Report to Community Advisory Committee on Planning

To: Chair and Members
From: Community Advisory Committee on Planning
Jana Kelemen, M.Sc.Arch., MUDS, RPP, MCIP,
Manager, Urban Design and Heritage
Subject: Heritage Alteration Permit application by M. Wales for 645
Lorne Avenue, Old East Heritage Conservation District
Date: November 9, 2022

Figure 2: Detail of Sheet 21, 1892, revised 1907 Fire Insurance Plan (courtesy Maps and Data Centre, Western University). The dashed line in front of the building indicates a verandah.

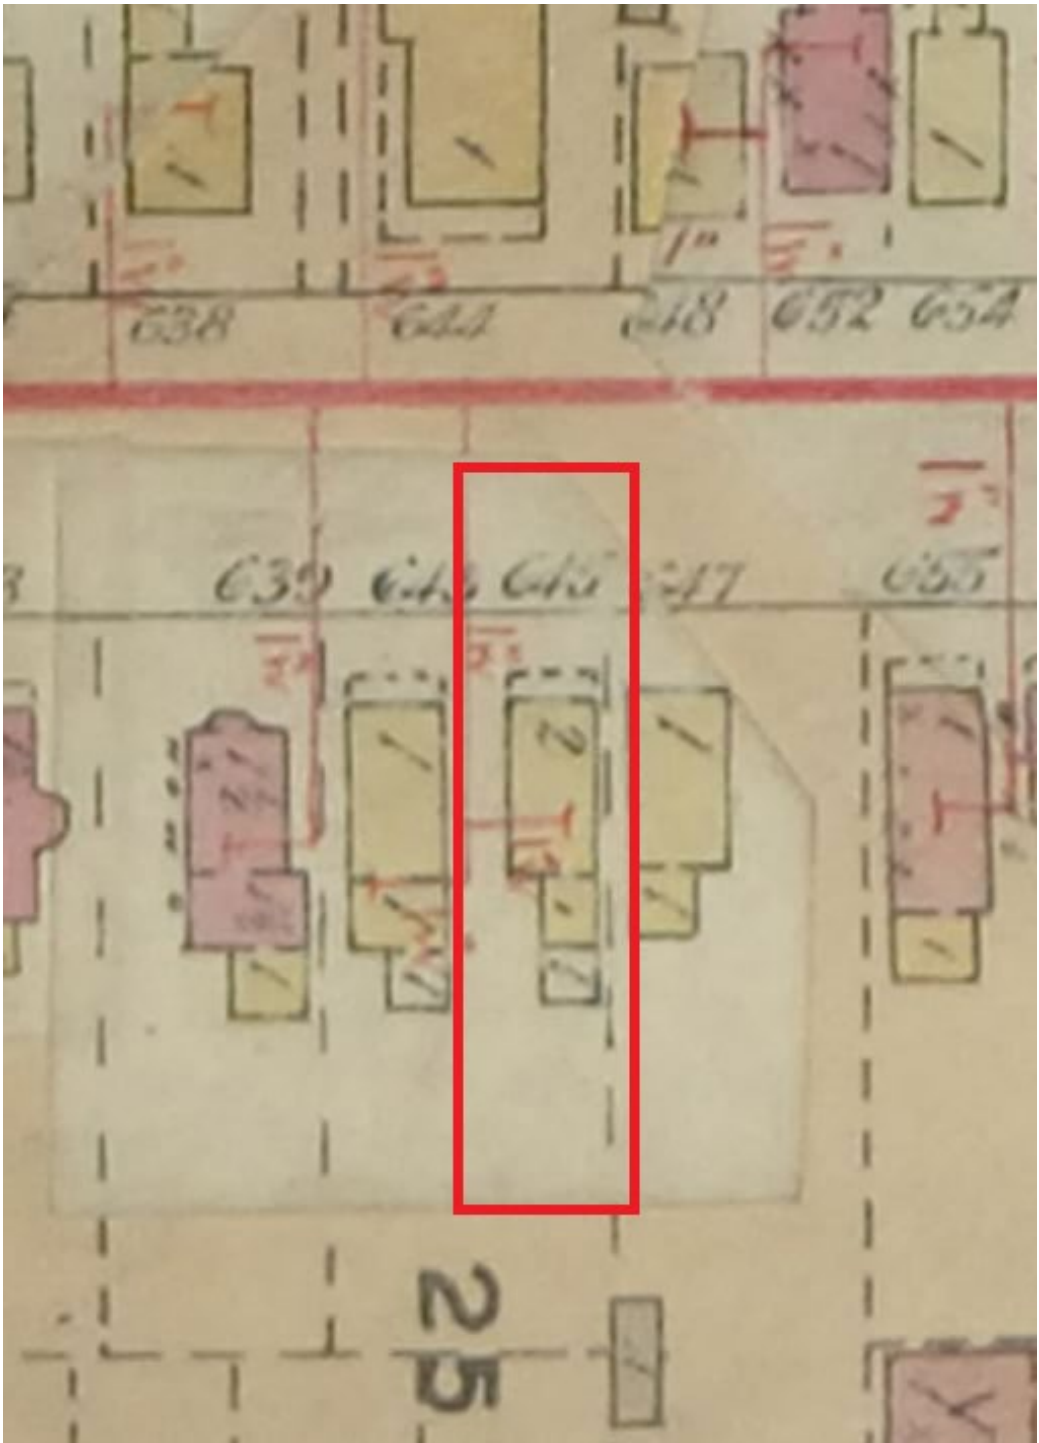
A verandah is shown on the 1892, revised 1907 Fire Insurance Plan for the property at 645 Lorne Avenue (see Figure 2, Appendix A). A similar verandah is shown on the 1912, revised 1915 Fire Insurance Plan and 1912, revised 1922 Fire Insurance Plan. However, the former verandah and balcony appear to date from the mid-twentieth century (see Appendix B). This dating is attributed to the use of rug brick balustrade and plinths which became more common into the 1930s, accompanied by metal railings that appeared more typical of an early post-WWII period, and could be accounted by several or successive alterations. It is unlikely that the verandah and balcony were an original conception, but of comparable size to what was shown in the Fire Insurance Plan.

Figure 4: Elevation drawing submitted as part of the Heritage Alteration Permit application showing the proposed changes to the heritage designated property at 645 Lorne Avenue. Note: not to scale.

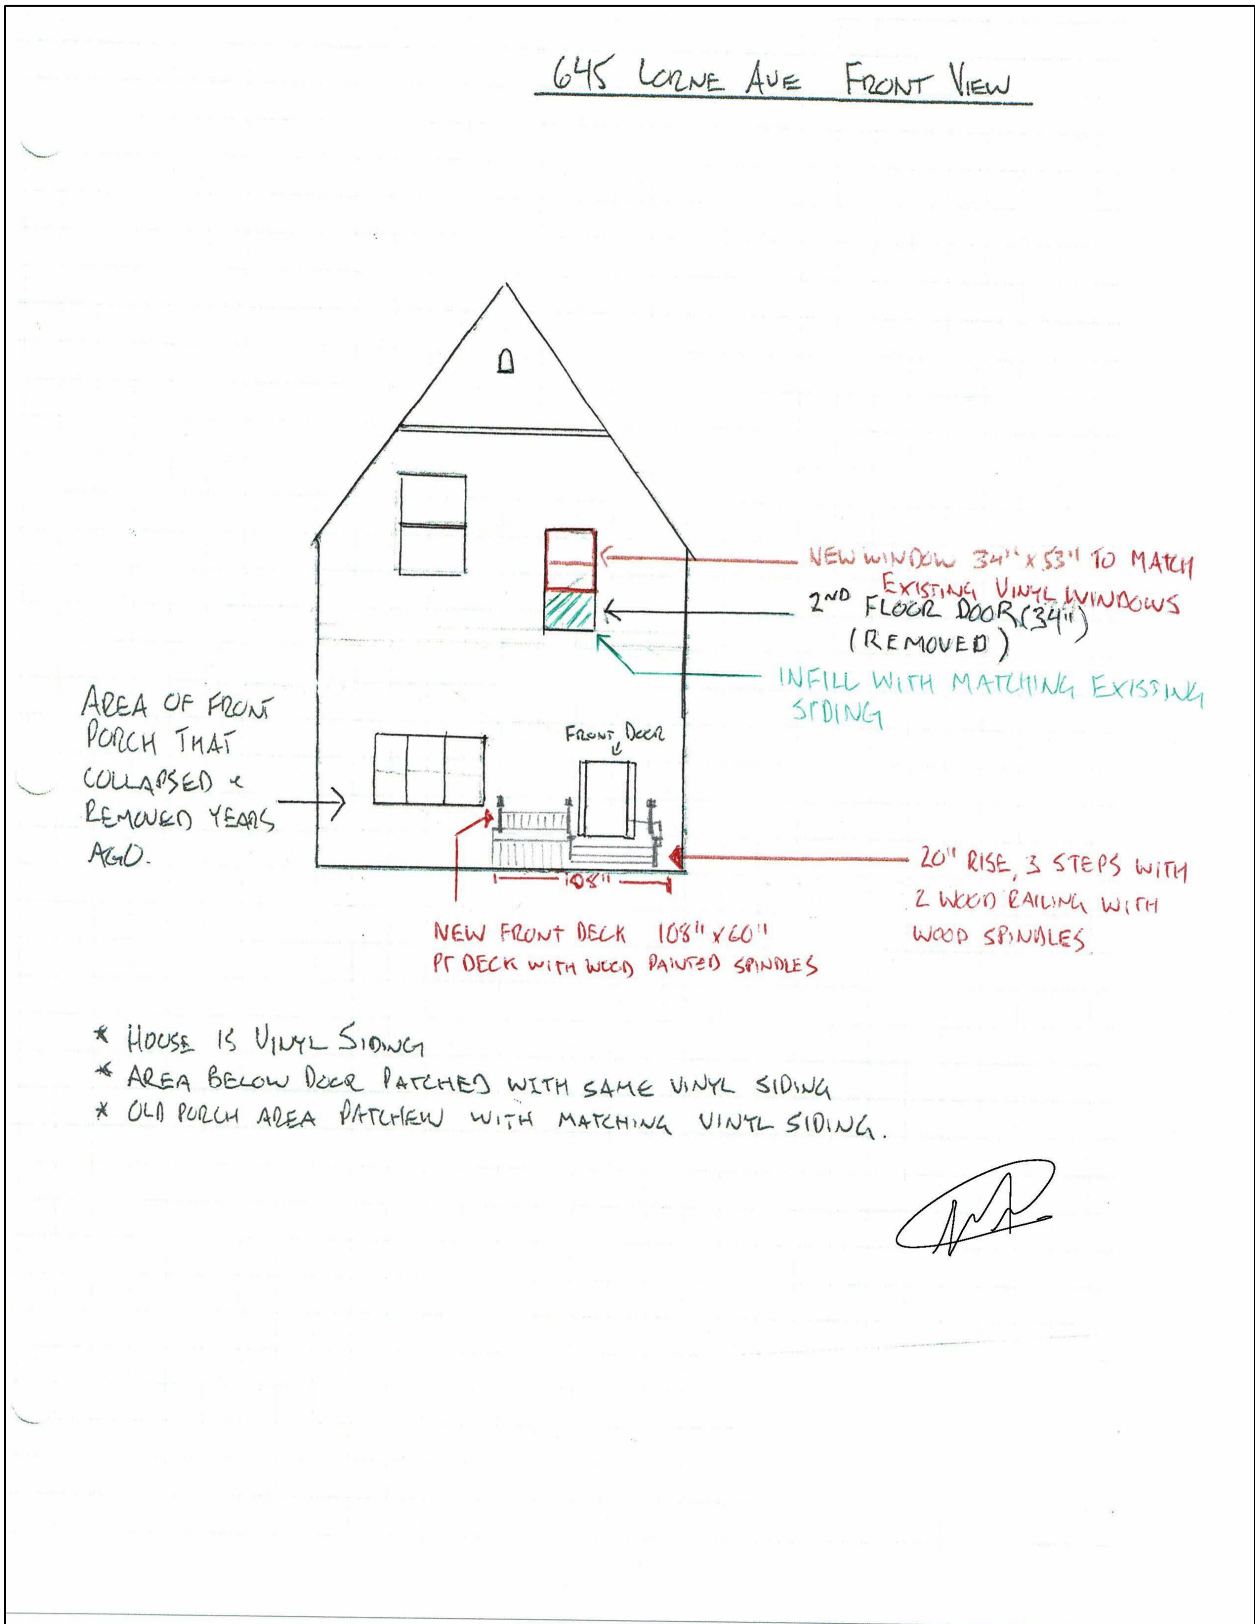
Recognizing that porches are an important part of the heritage character of the Old East Heritage Conservation District, a smaller uncovered porch at the front doorway of the house at 645 Lorne Avenue has been proposed (see Appendix C). The proposed porch is approximately 108” in width by 60” in depth, approximately 20” in height to meet the front doorway. Pressure treated wood has been proposed as the primary material for the porch, including steps, deck, and wood spindles.

While not of the same size or scale as the former verandah and balcony, the proposed porch will maintain this important feature and make contributions supporting the heritage character of the Old East Heritage Conservation District. To ensure that the porch is appropriate for the property and Old East Heritage Conservation District, turned wood spindles should be used, a square or diamond pattern lattice-style wood porch skirt installed, all exposed wood be painted, and consideration be given to using the colour palette of the Old East Heritage Conservation District (see Figure 3, Appendix A).

The applicant has proposed to insert a window into the doorway opening. This would retain the opening on the façade and its associated trim detailing. As the proposed window (34” wide by 53” in height) does not fill the entire doorway opening (generally about 80” in height), the lower portion of the opening would be clad in vinyl siding to match the front façade of the house. The applicant advised that siding can be salvaged from a location on the house not visible from the street to ensure the siding matches. A sill and other finishing details would be installed to match the adjacent window opening.

Approval of the Heritage Alteration Permit application seeking retroactive approval for the removal of the verandah and balcony and approval of the proposed porch and doorway-window alterations with terms and conditions is recommended. Terms and conditions are recommended to ensure compatibility with the heritage character of the property at 645 Lorne Avenue and the Old East Heritage Conservation District.
